FORM
4
Rev 12/05State of Colorado
Oil and Gas Conservation Commission

SUNDRY NOTICE

1. OGCC Operator Number: 100185 API Number: 05045212900000
 2. Name of Operator: Encana Oil & Gas (USA) Inc. OGCC Facility ID #
 3. Well/Facility Name: Federal Well/Facility Number: 21-9D (PJ21)
 4. Location (QtrQtr, Sec, Twp, Rng, Meridian): NWSE 21, T7S, R95W, 6 PM

Encana Federal 21-9D (PJ21) 045-21290

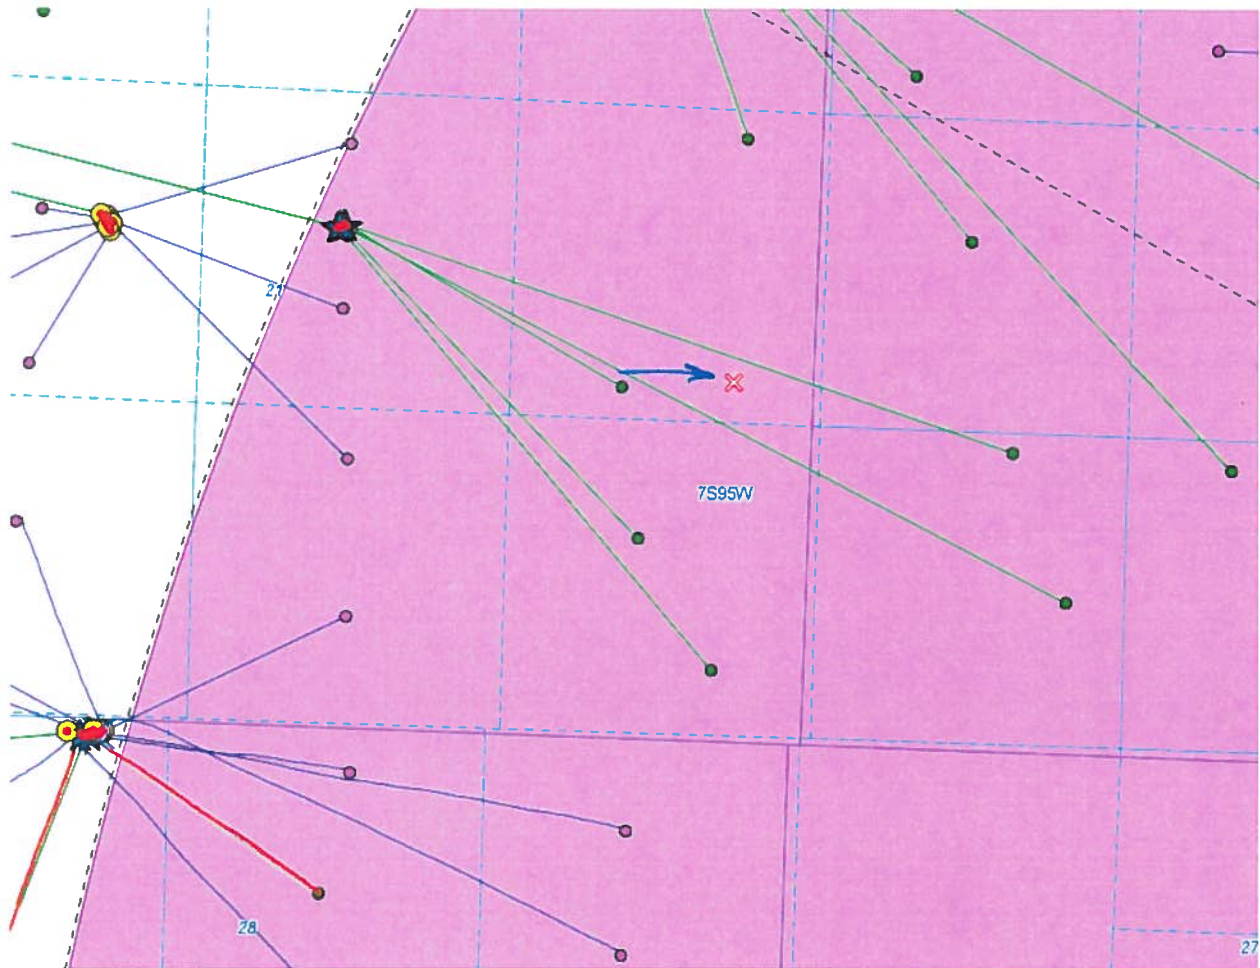
- Section 21 7S 95W
- BHL revised via sundry notice:
 - BHL footages on scout card are correct
 - TPZ footages on scout card should be the same as BHL - need to be updated
 - BHL on map needs to be updated – moved to red "X" = new proposed Bit L.
ATE 1/31/13

Planned PJ21, PH21, PC22 wells.

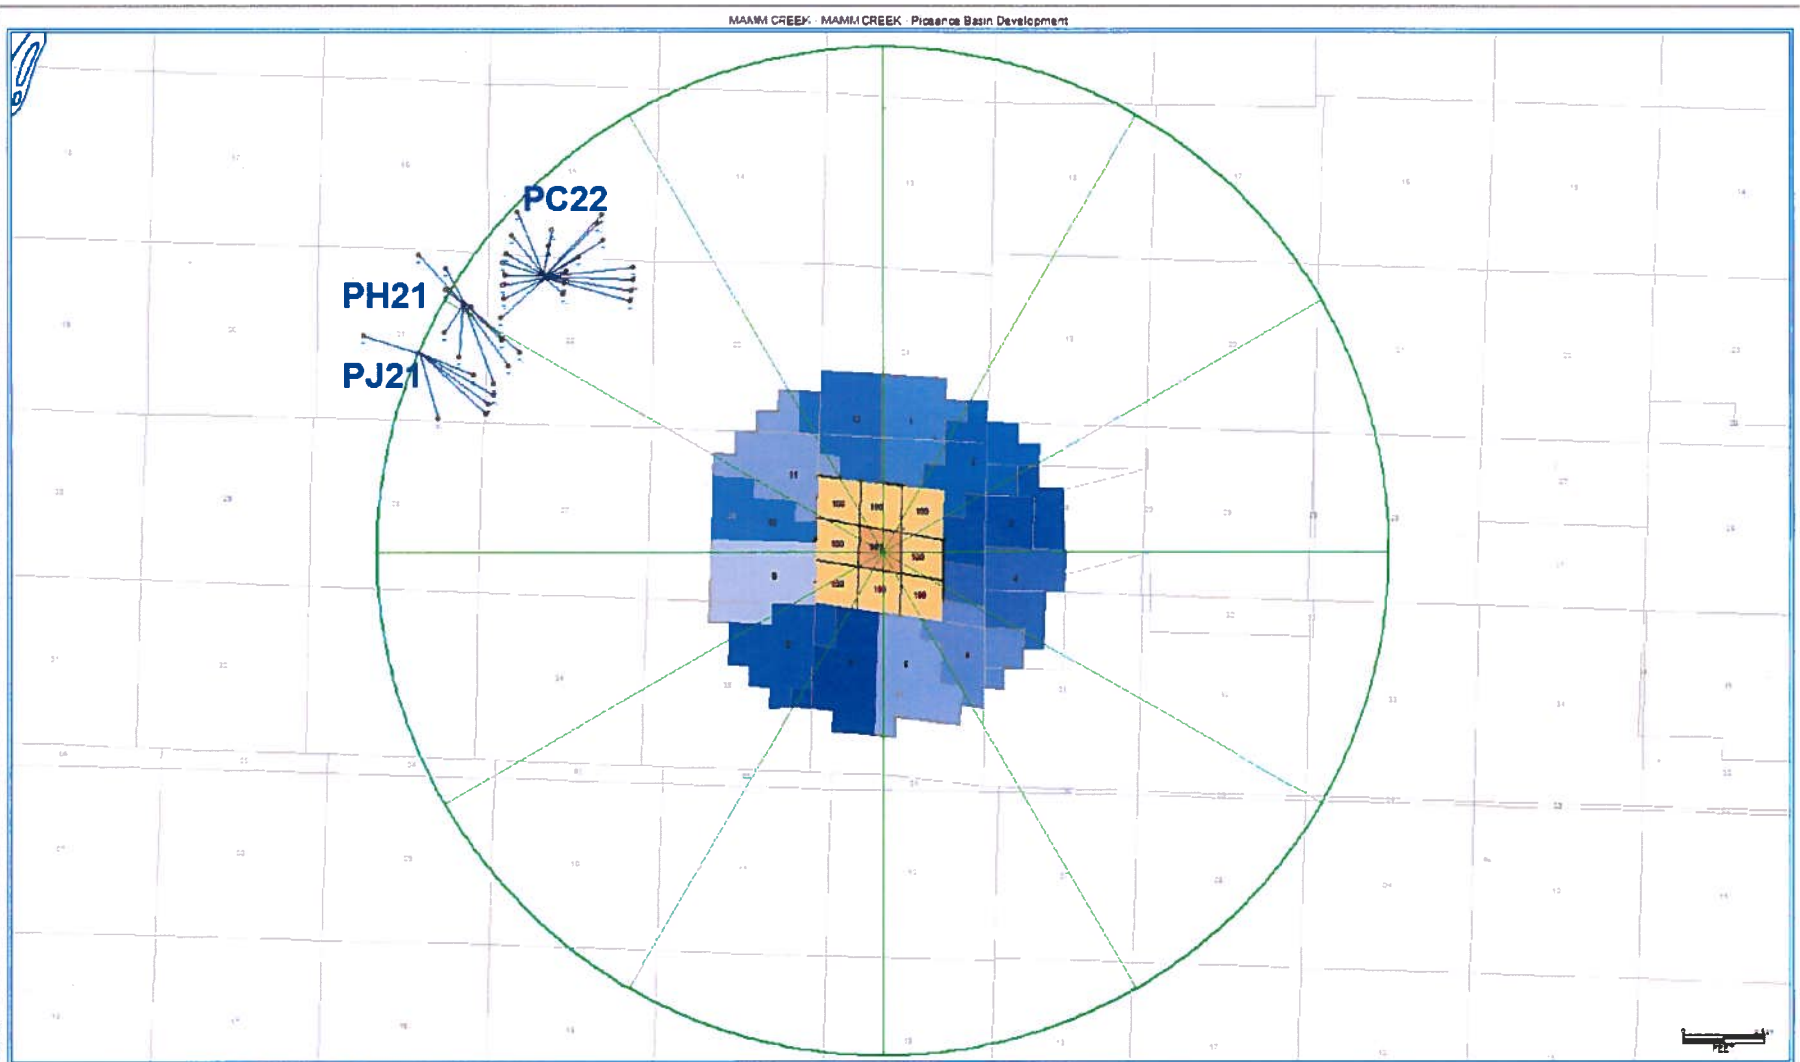
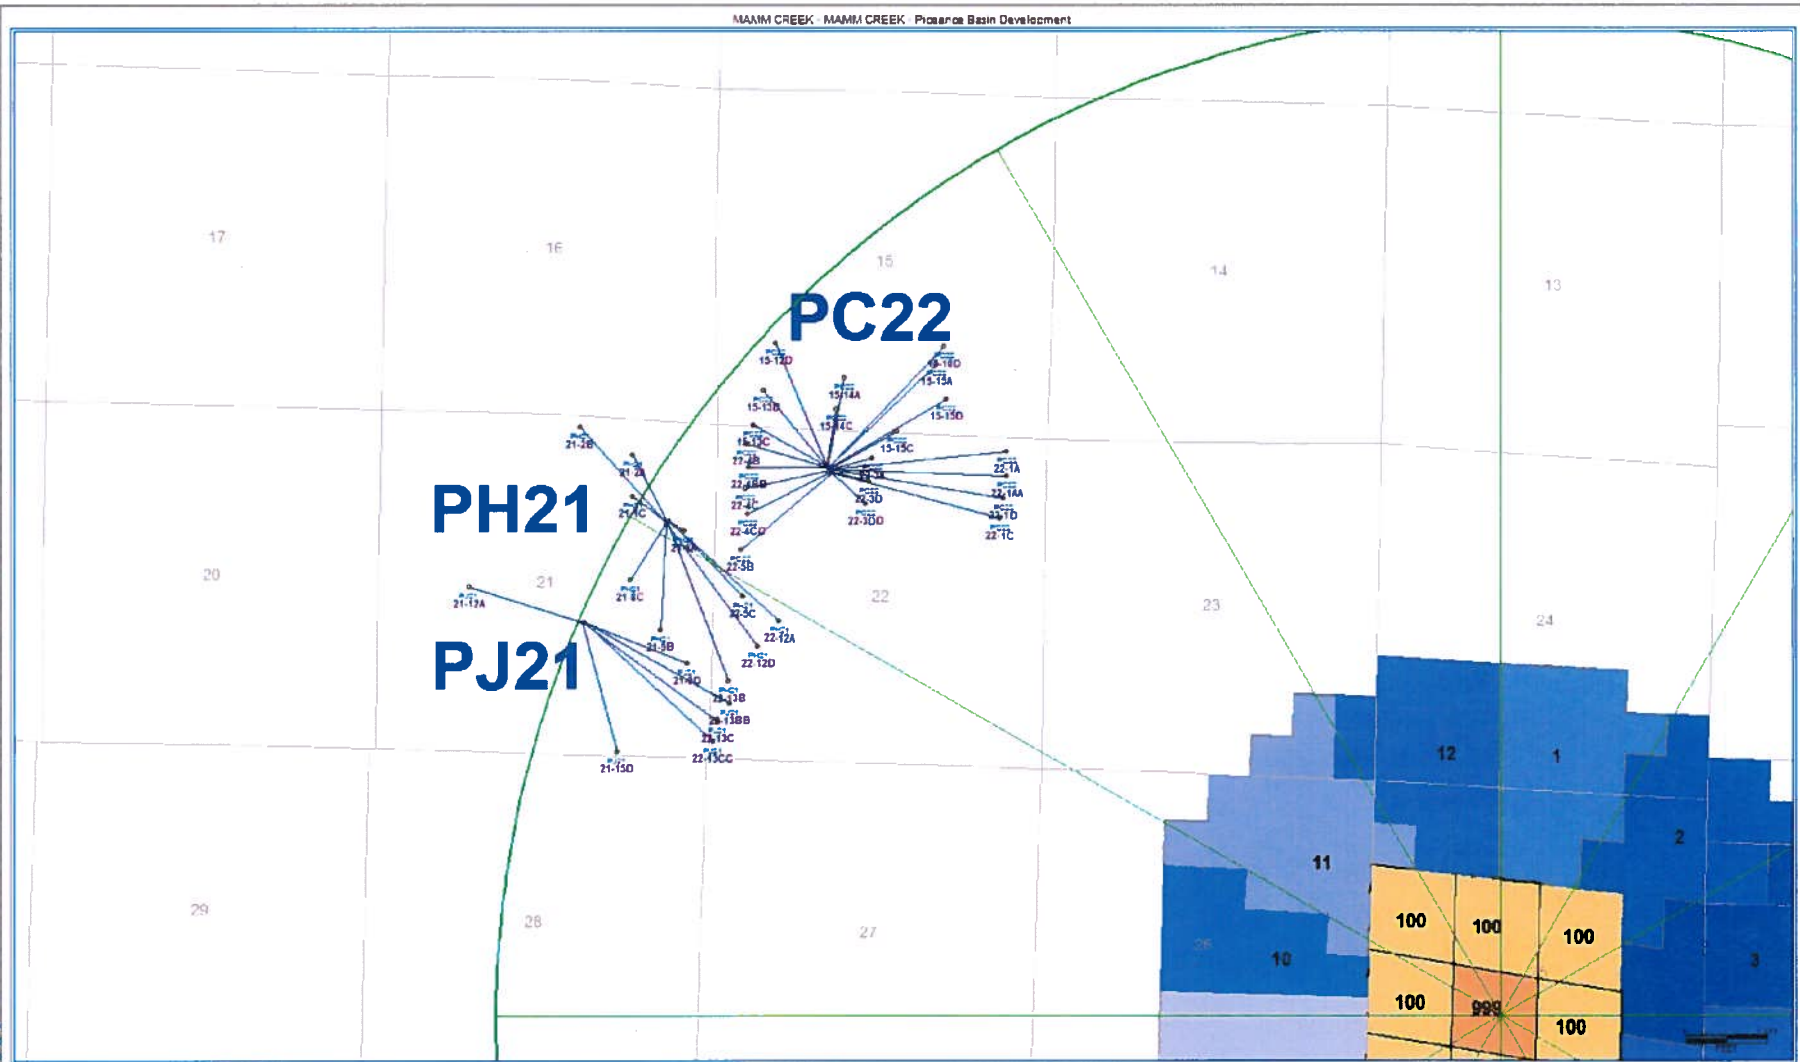
The new BHL is 1497' FSL/366' FWL of Sec. 21 T7S, R95W FEL 39.419893/107.993993
 Justification for the removal of the COAs is listed below, maps identifying the BHL with the RSAP Area are attached
